MIL-PRF-6106/19E
AMENDMENT 3
10 July 1999
SUPERSEDING
AMENDMENT 2
15 June 1999

PERFORMANCE SPECIFICATION SHEET

RELAYS, ELECTROMAGNETIC, PERMANENT MAGNET DRIVE,
25 AMPERES, SPDT, HERMETICALLY SEALED

This amendment forms a part of MIL-PRF-6106/19E, dated 24 October 1990, and is approved for use by all Departments and Agencies of the Department of Defense.

FIGURE 1. Relay, outline drawing.

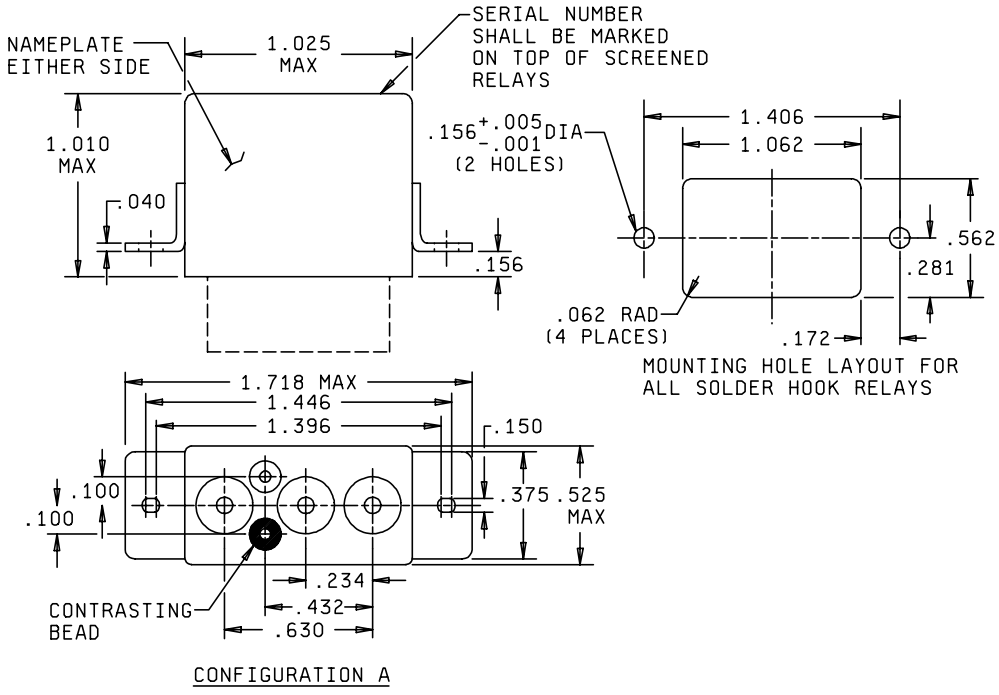
* FIGURE 1, Configuration A: delete and substitute the following to correctly show the mounting flange width.

SOCKET PIN TERMINAL

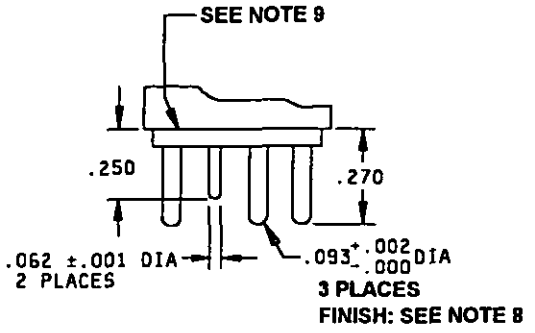
* FIGURE 1, socket pin terminal: delete and substitute
